**Eastern Corridor Segments II and III
Red Bank Corridor to I-275/SR 32 Interchange (PID 86462)
Public Open House
Meeting Summary Report**

**October 24 and 25, 2018 Public Open House
MEETING SUMMARY REPORT**

**October 24 and 25, 2018 Public Open House
CONCEPT EVALUATION and COMMENT SUMMARY**

VILLAGE OF NEWTOWN FOCUS AREA CONCEPTS B8, B9 AND B10, BOARD 11

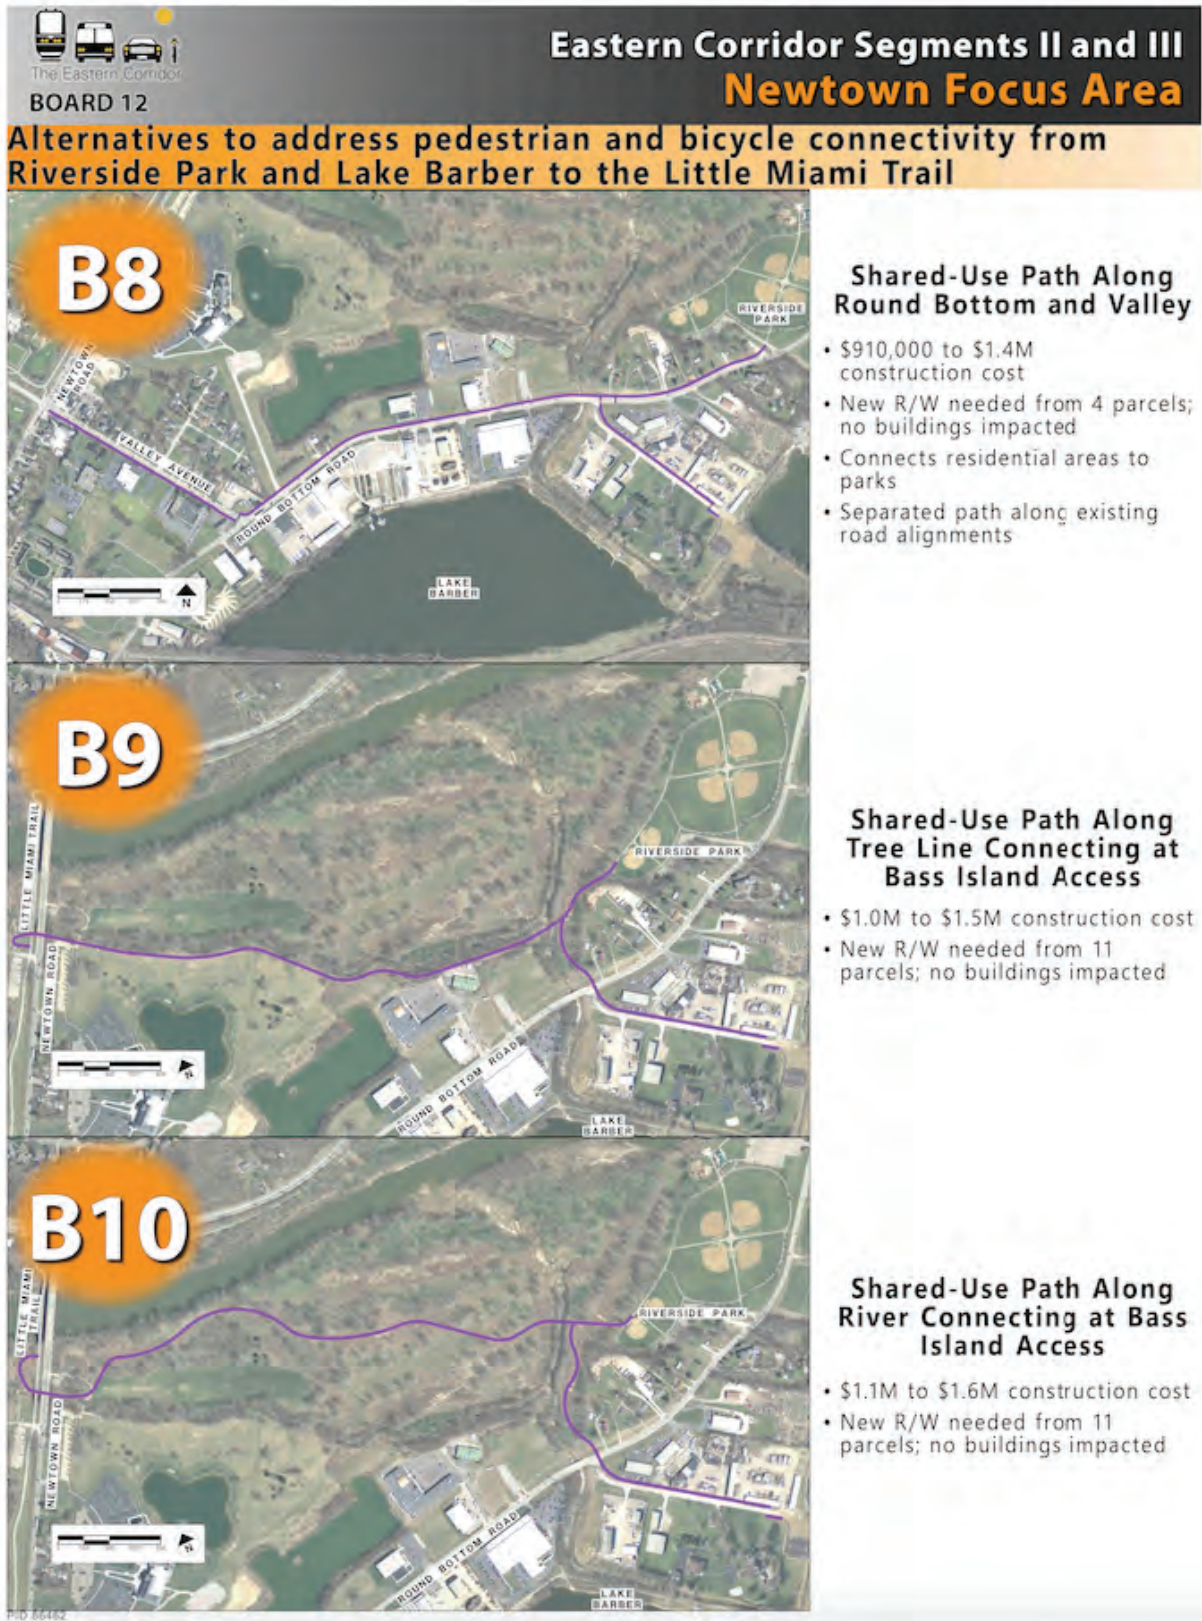
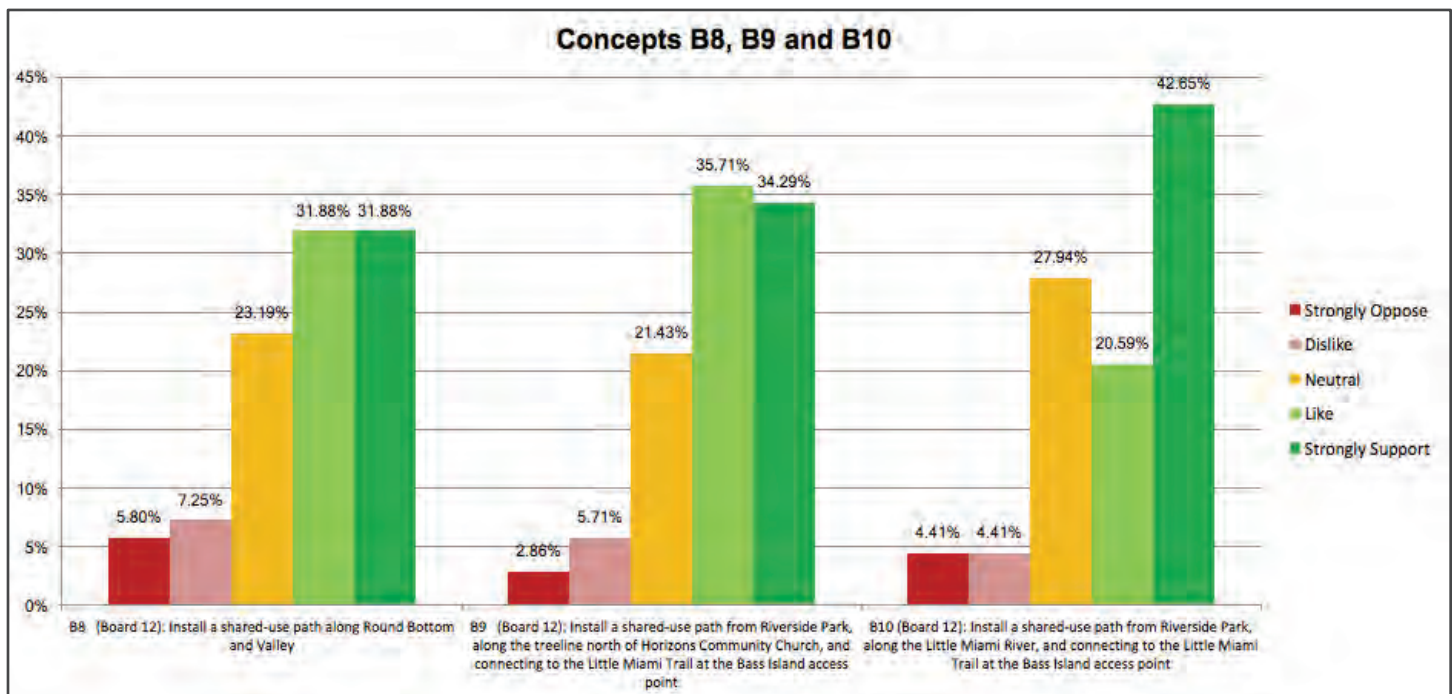
NO.	COMMENT	RESPONSE
1	Prefer B8 over B9 and 10. B8 would connect to more destinations.	Thank you for your comment. Your input is appreciated and will be taken into consideration as we evaluate the options and develop our recommendations.
2	B8, B9, B10 - Either works, after costs considered.	Thank you for your comment. Your input is appreciated and will be taken into consideration as we evaluate the options and develop our recommendations.

NO.	COMMENT	RESPONSE
1	9 – Cost issue.	Thank you for your comment. Your input is appreciated and will be taken into consideration as we evaluate the options and develop our recommendations.
2	B8, B9, B10 - Either works, after costs considered	Thank you for your comment. Your input is appreciated and will be taken into consideration as we evaluate the options and develop our recommendations.

SR 32 and Little Dry Run Intersection Improvements

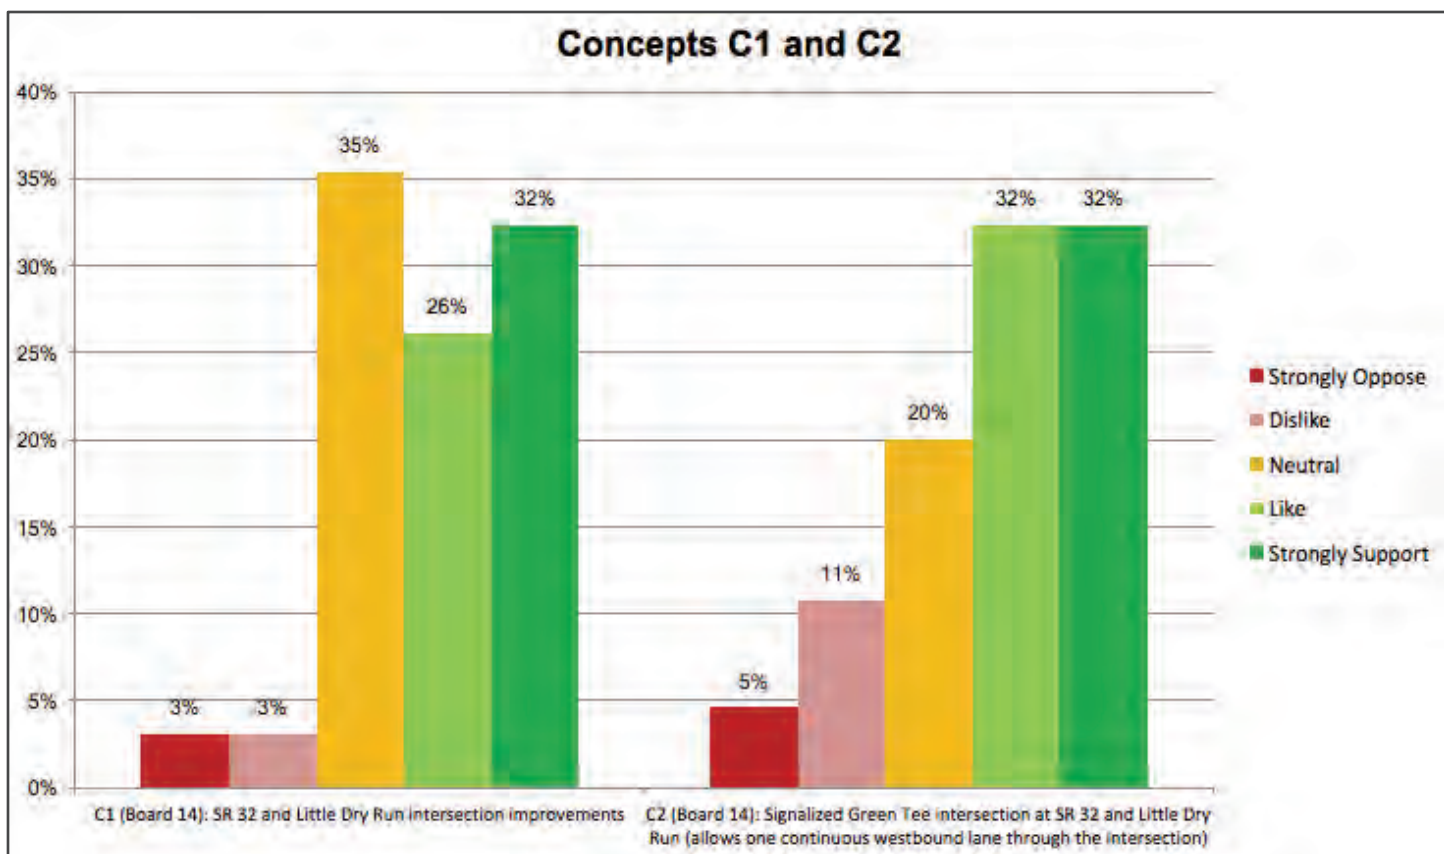
NO.	COMMENT	RESPONSE
C2	This would make it way too difficult for traffic coming from Little Dry Run to merge with the huge volume of traveling on westbound 32 during rush hour.	Thank you for your comment. Your input is appreciated and will be taken into consideration as we evaluate the options and develop our recommendations. While this project stands alone, we are considering issues in the corridor when evaluating project priority. This project would not likely be constructed until an improvement at SR-32 & Round Bottom is constructed first.

CONCEPTS C5, C6 AND C7, BOARD 16

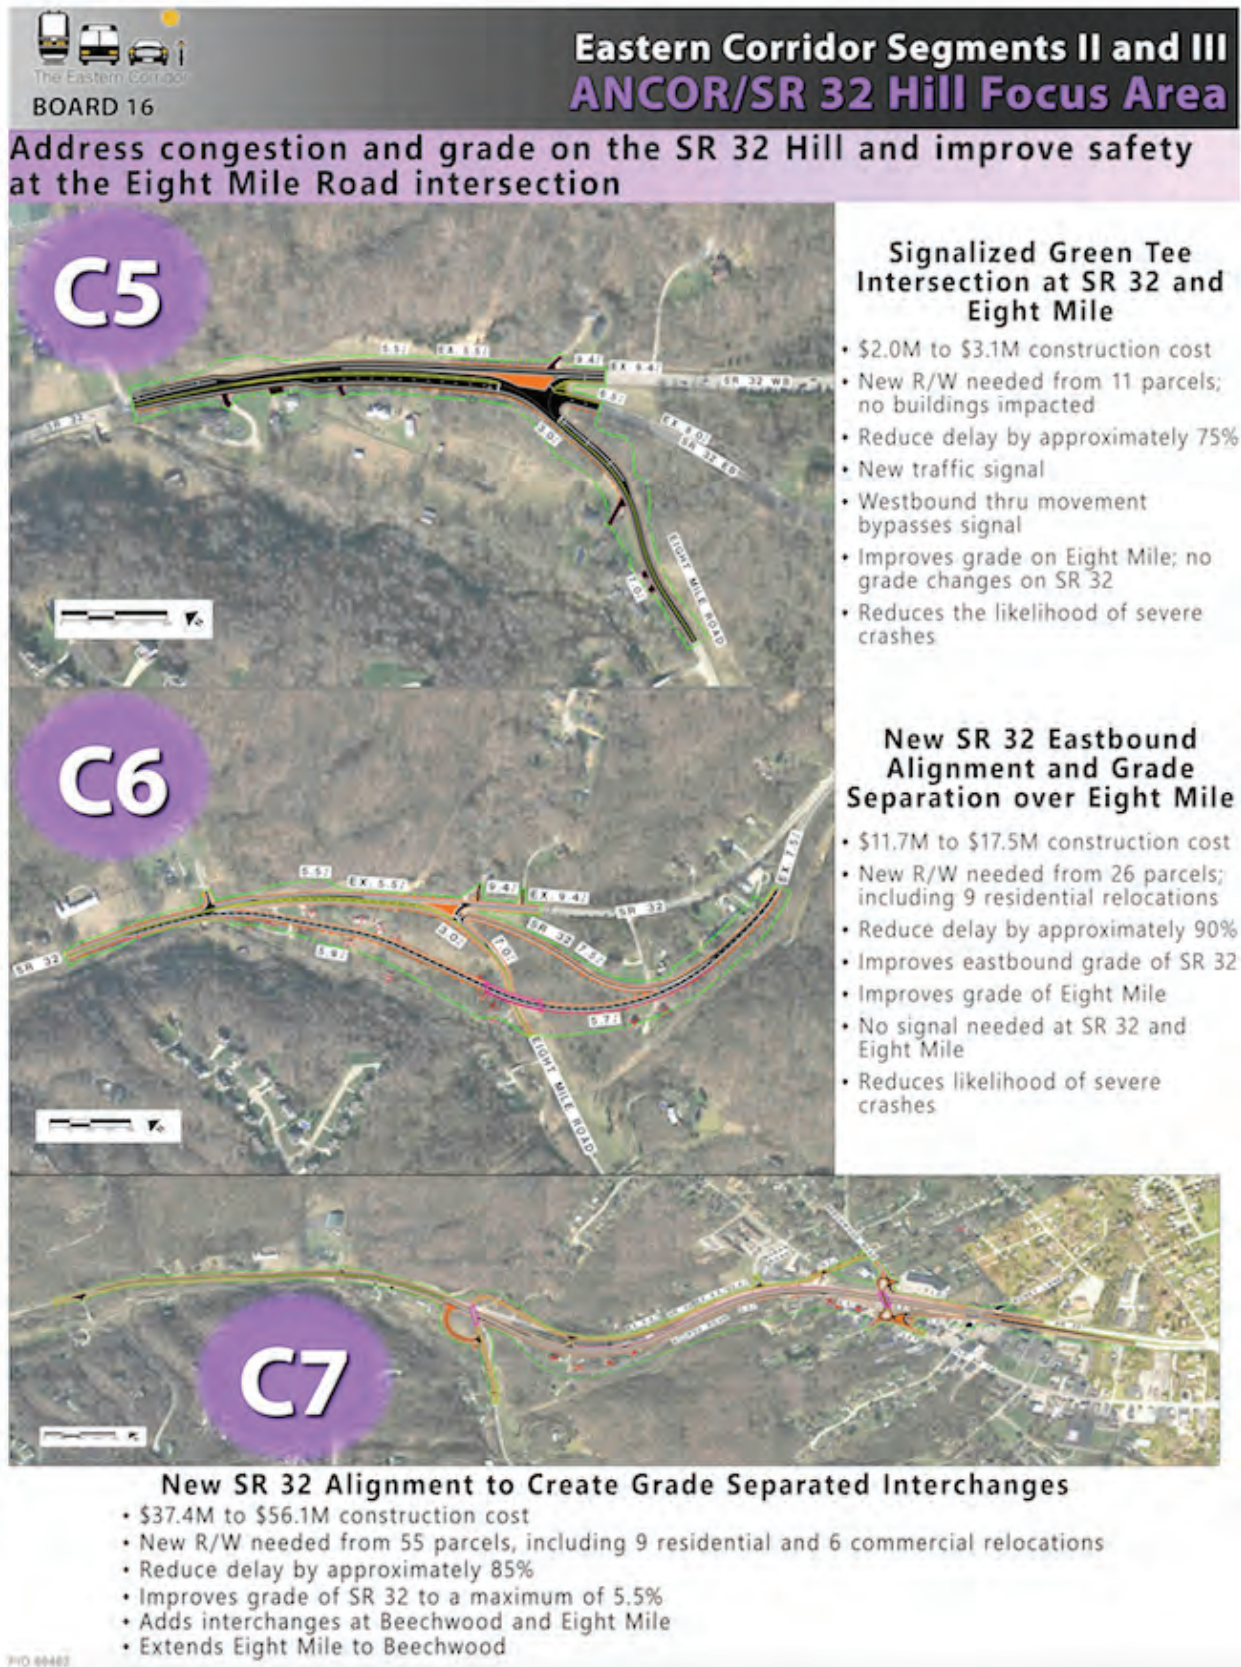
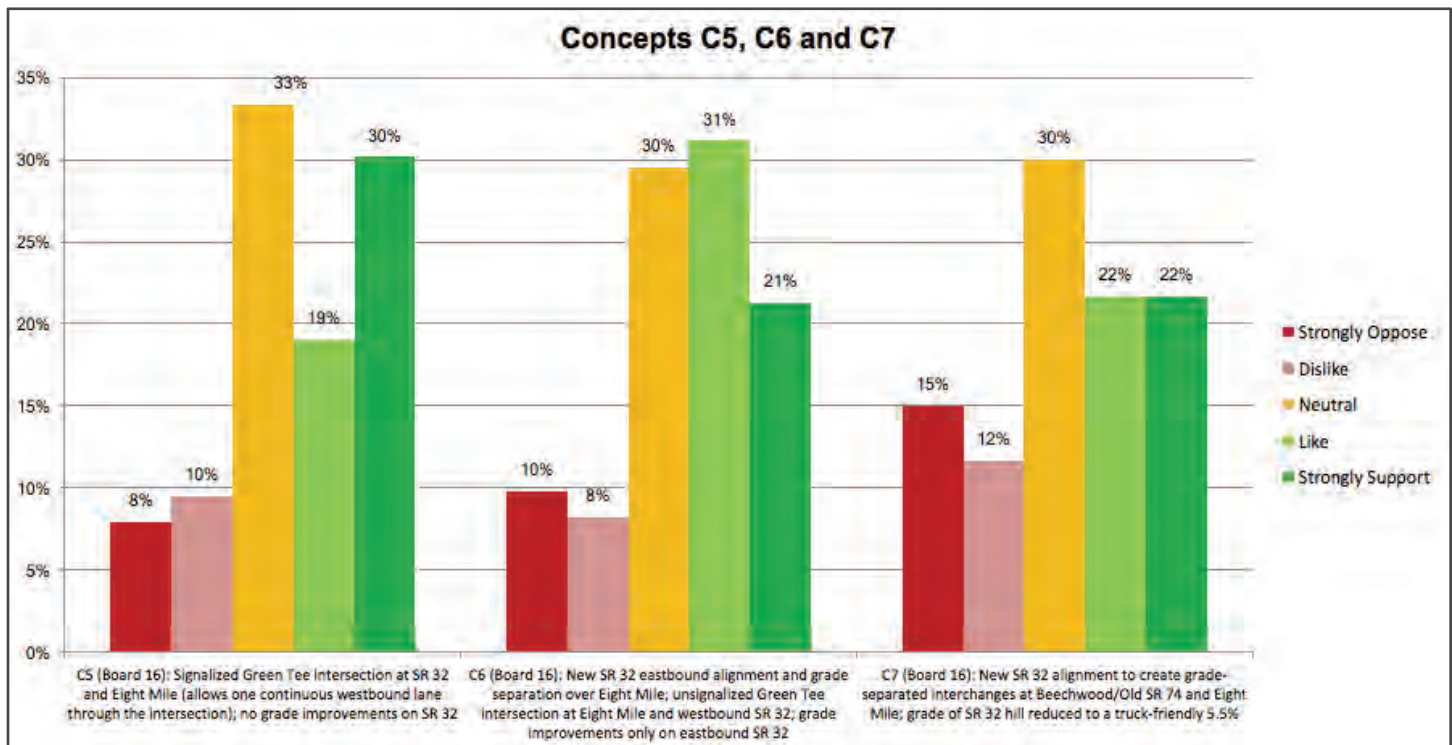
NO.	COMMENT	RESPONSE
1	C6 - Separated area is Anderson Township green space and is protected from improvements.	Thank you for your comments. We appreciate the information you have shared and will consult with Anderson Township accordingly. This information will be taken into consideration as we evaluate the options and develop our recommendations.
2	Regarding C6 and C7 - A colossal waste of money that would be better spent on other projects.	Thank you for your comment. Your input is appreciated and will be taken into consideration as we evaluate the options and develop our recommendations.

NO.	COMMENT	RESPONSE
1	C7 - adds traffic to Beechwood?	Thank you for your comment. This concept would likely increase traffic on Beechwood on the first block north of SR 32 up to Craig Road where 8-Mile Road would connect.
2	Regarding C6 and C7 - A colossal waste of money that would be better spent on other projects.	Thank you for your comment. Your input is appreciated and will be taken into consideration as we evaluate the options and develop our recommendations.
3	<i>Received via email:</i> Although most expensive, the C7 alternative seems to be the best. It eliminates signals and provides improved roads which should greatly improve traffic flow. The biggest traffic problem with this section is turning from 8 mile onto SR 32 and having to stop at a traffic light at beechwood. Eliminating both of those would greatly improve traffic.	Thank you for your comments. Your input is appreciated and will be taken into consideration as we evaluate the options and develop our recommendations.

ANCOR/SR HILL FOCUS AREA CONCEPTS C8 AND C9, BOARD 17

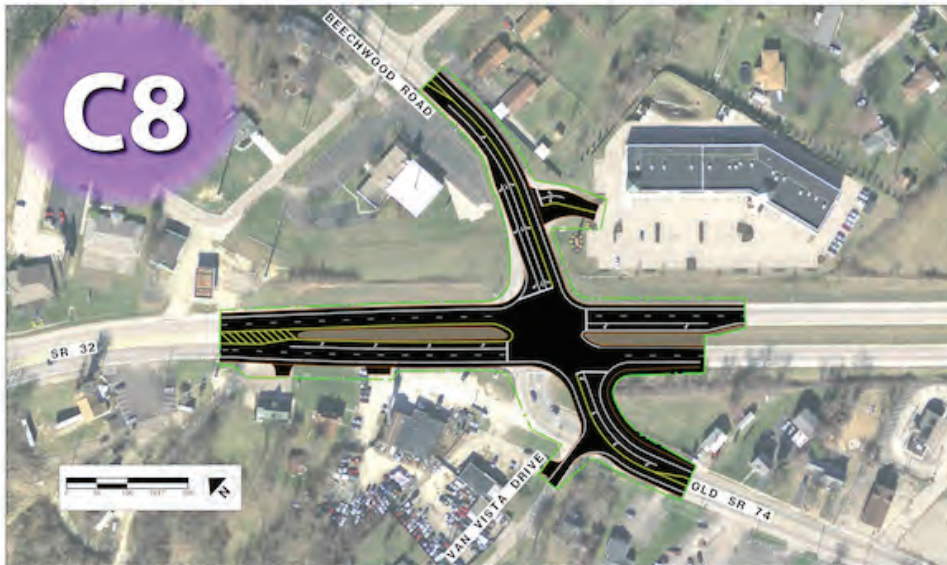
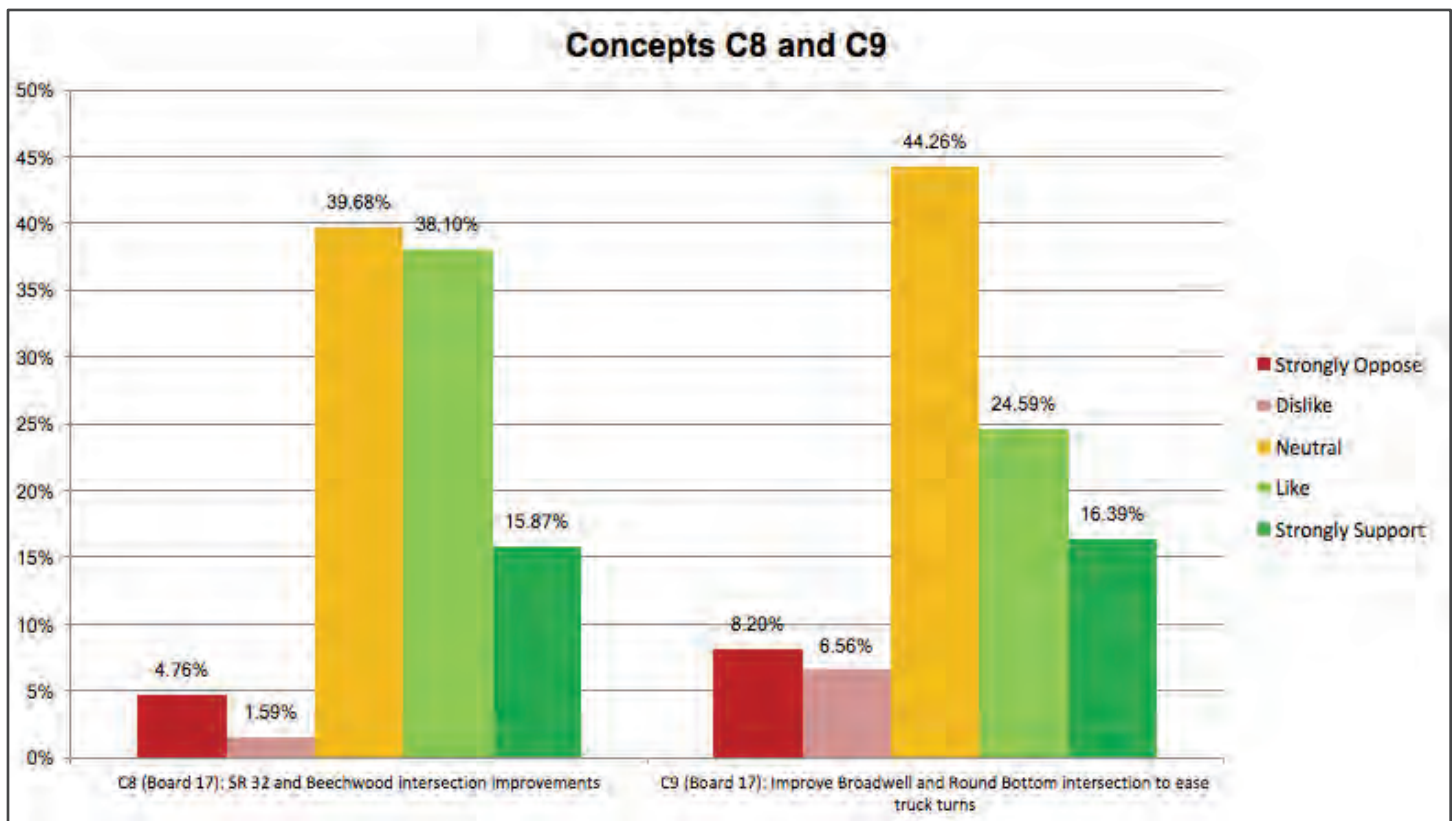
NO.	COMMENT	RESPONSE
1	C8 - Improvements identified in your plan do NOT include a dedicated westbound turn lane onto Beechwood (BUT SHOULD), noting extra pavement exists and a "do not drive on marked shoulder" signage in place prohibits usage - THIS SHOULD BE A "NO BRAINER," and it appears you missed it (very limited cost, but big improvement potential).	Thank you for your comments. We appreciate the idea you have suggested and have evaluated whether a dedicated right (westbound) turn lane onto Beechwood should be implemented in this location. Based on our traffic data, we have determined that there will be a 10% benefit to the overall delay at the intersection during the PM peak hour. Therefore, we will include a right turn lane onto Beechwood in the Implementation Plan.
	Thanks for your work and consideration!
